Rocky Mountain Arsenal
North Boundary System Component
Response Action Assessment

Final Technical Plan
(Version 3.1)
February 1988
Contract Number DAAK11-84-D-0016
Task Number 36

8.5 RECOMMENDATIONS	8-13
9.0 MANAGEMENT AND ADMINISTRATION	9-1
BIBLIOGRAPHY	1
APPENDICES	
APPENDIX A-LETTER TECHNICAL PLANS	
APPENDIX B-COMMENTS AND RESPONSES

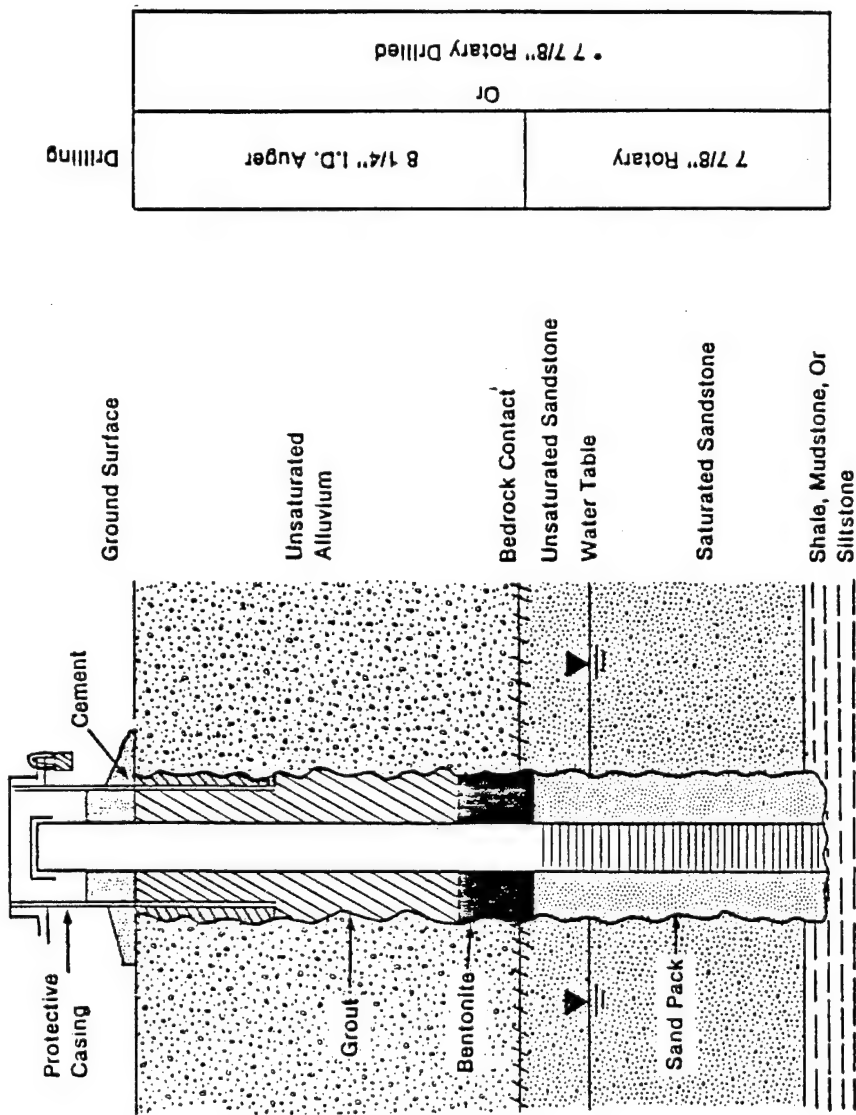
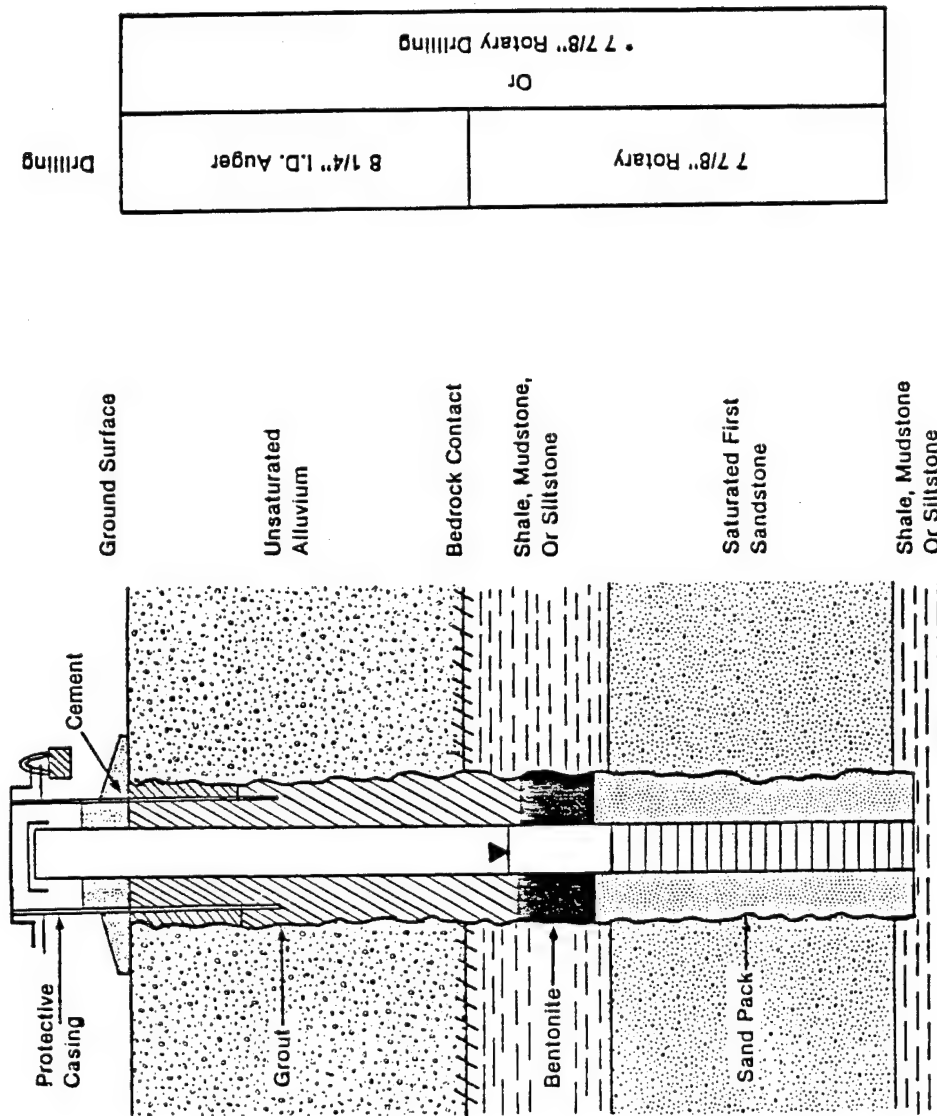
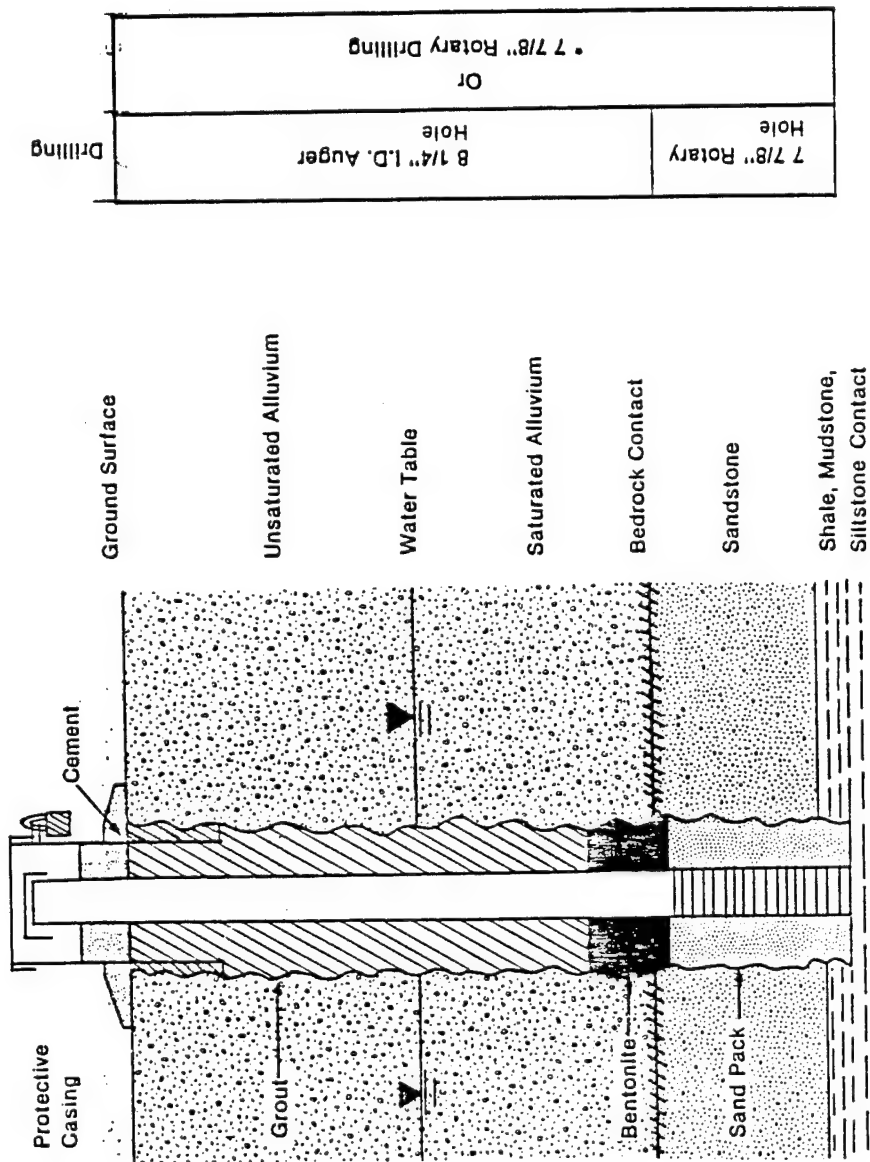
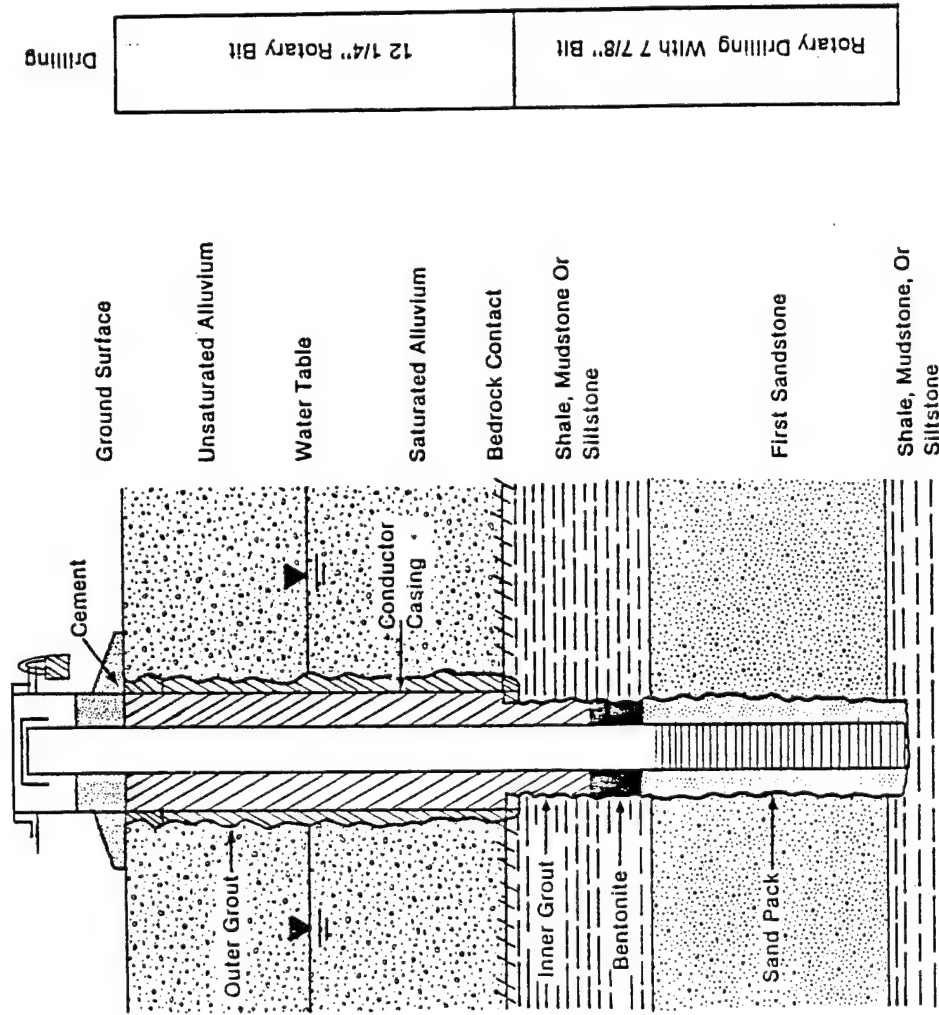
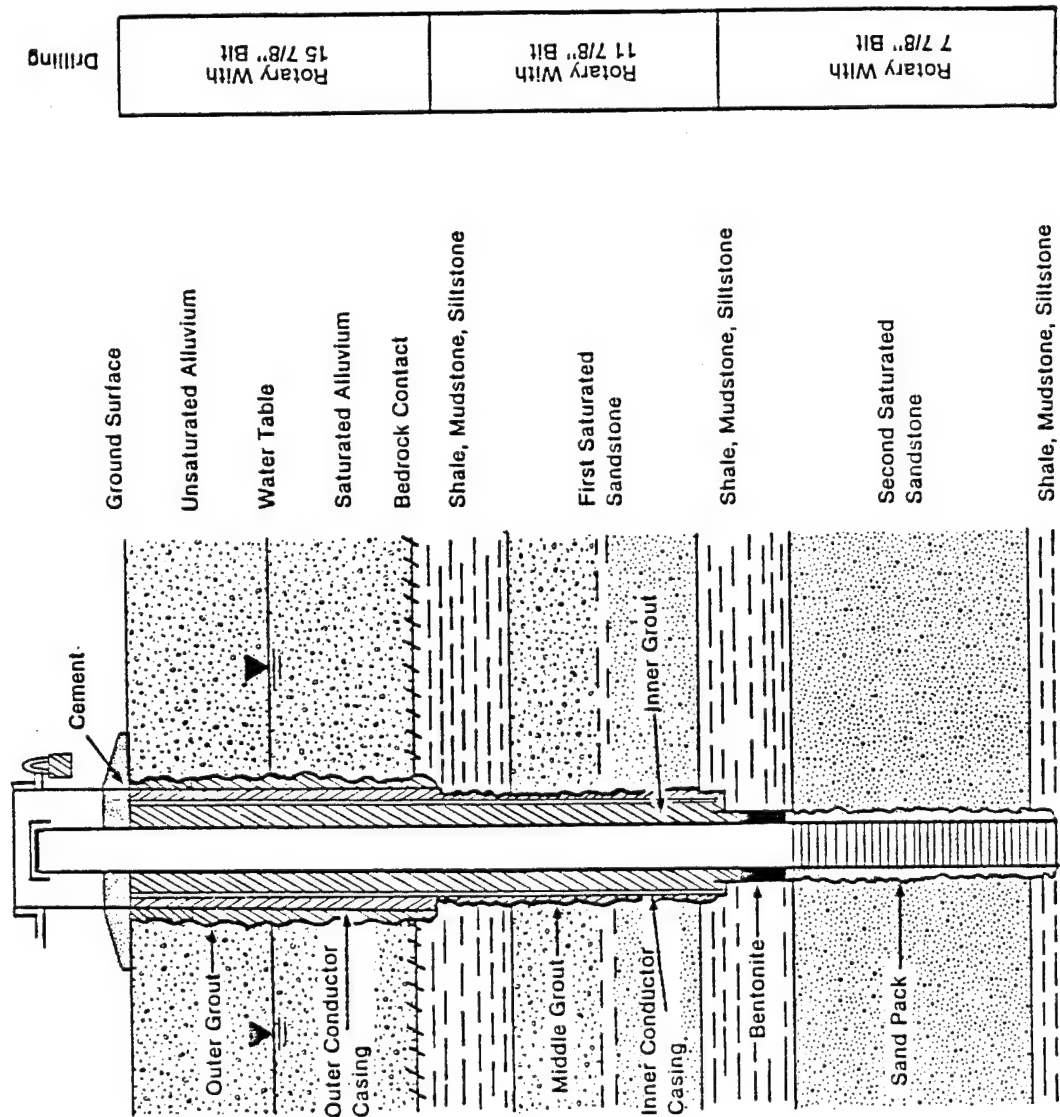
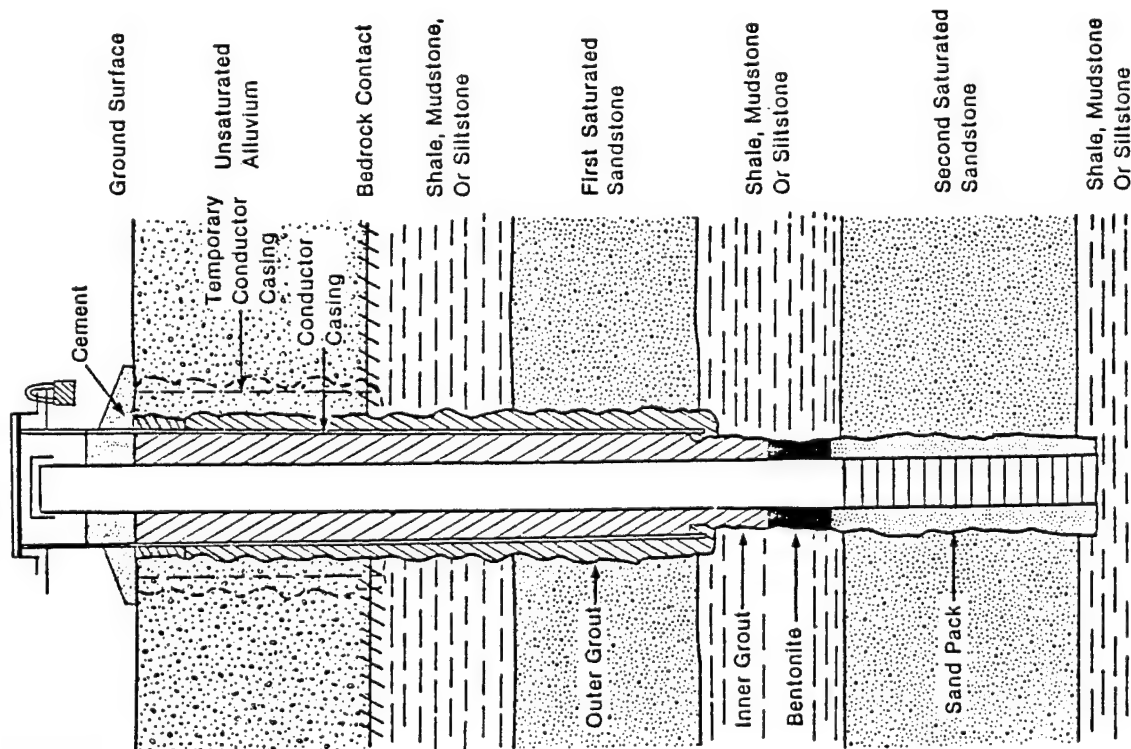
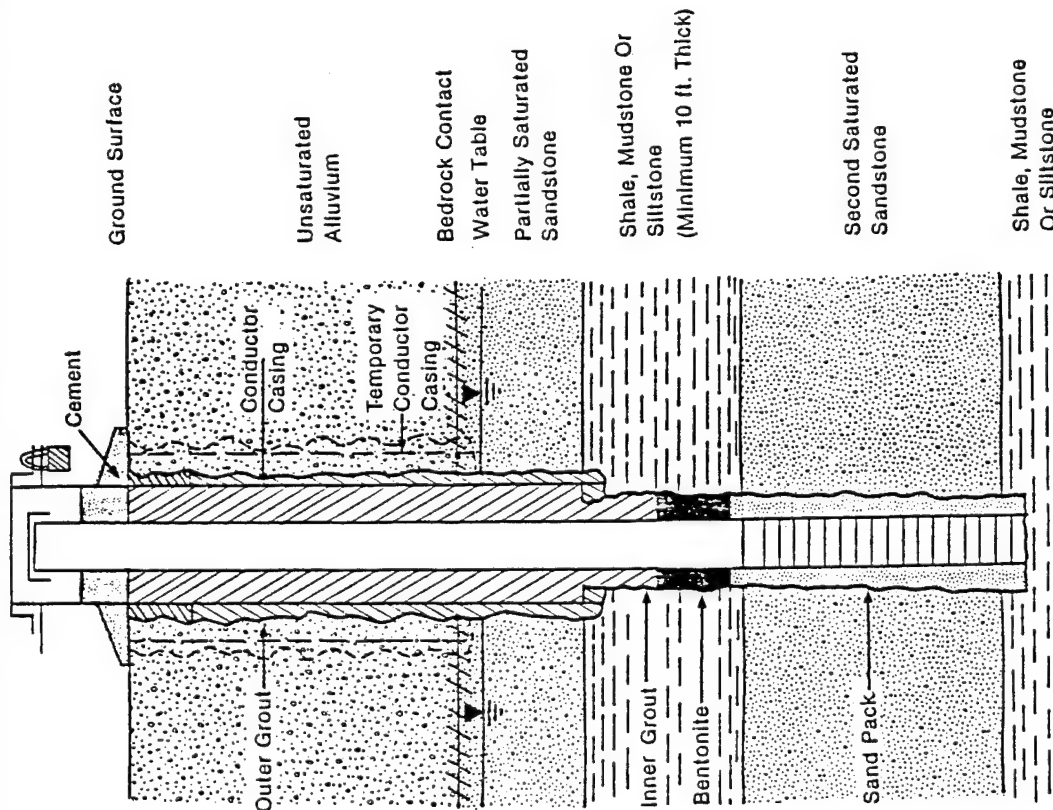
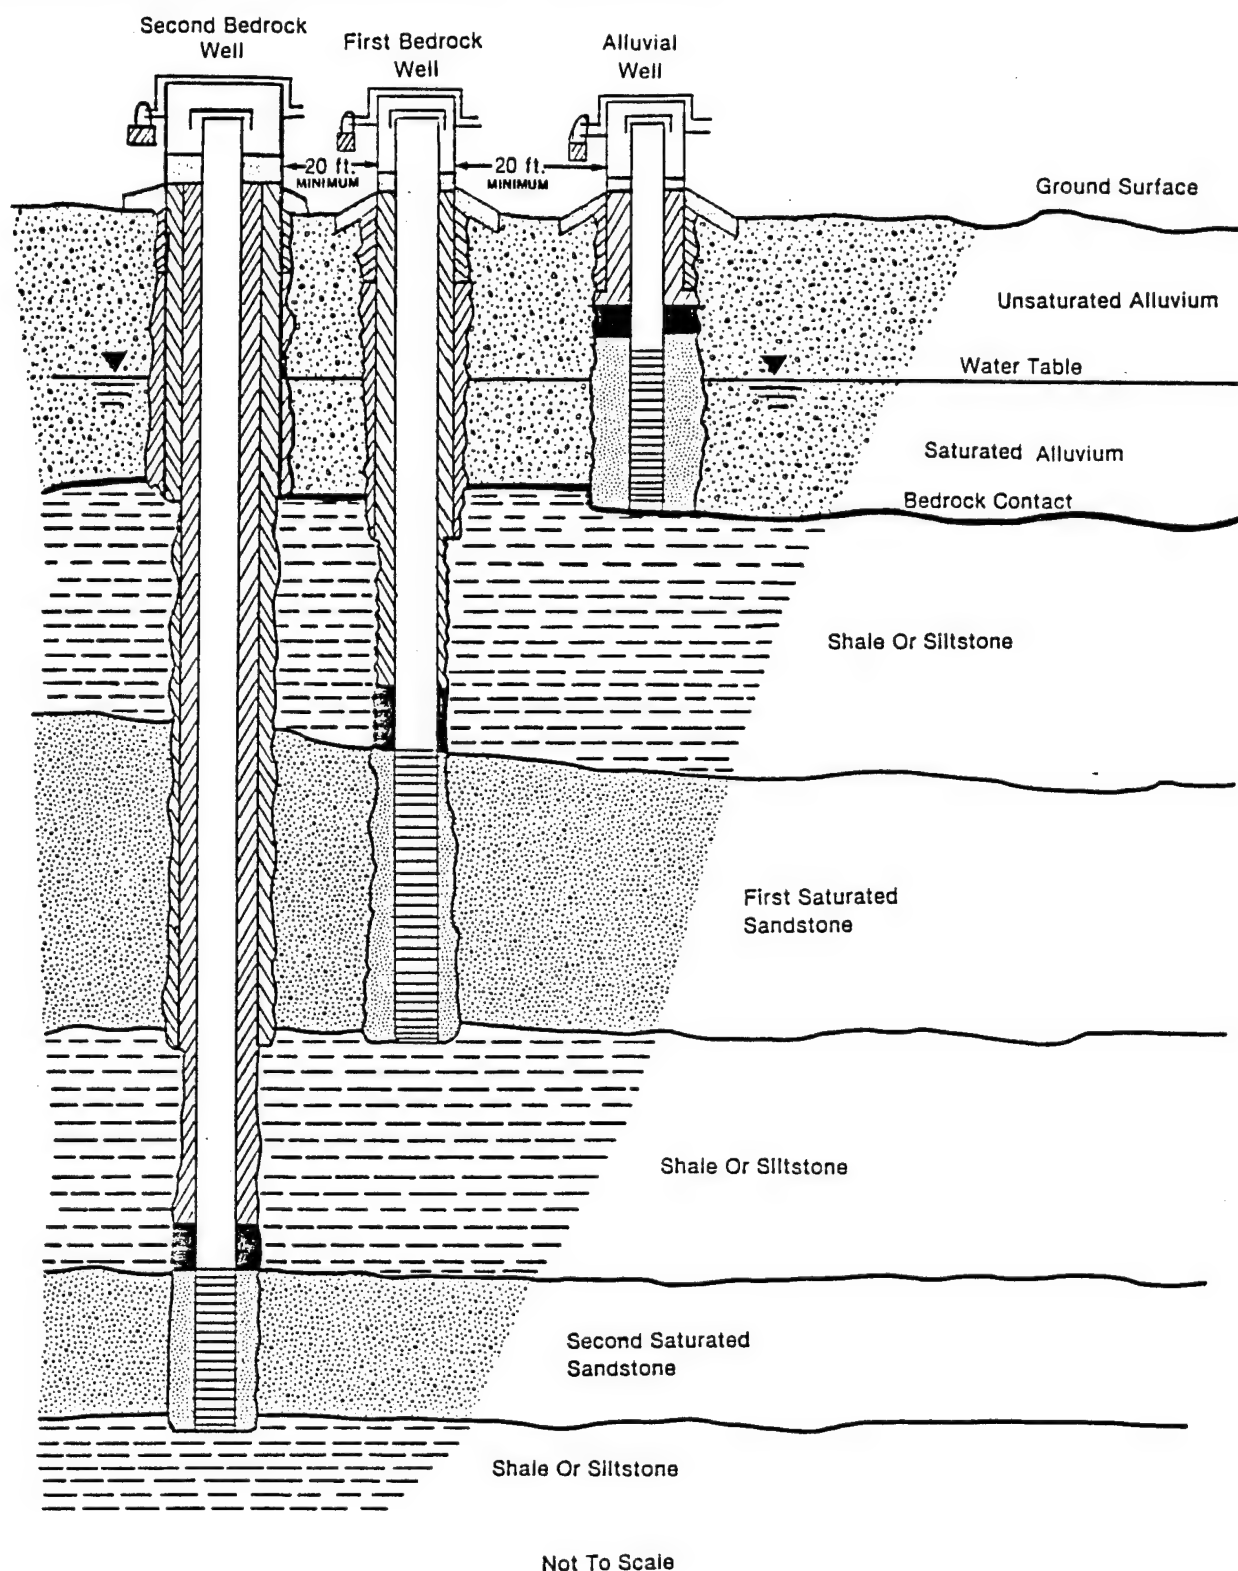
Figures 3.2-2a through 3.2-3. Construction details and contingencies for installing monitoring wells in shales/claystones of the Denver aquifer that show evidence of fracturing must be included in the technical plan.
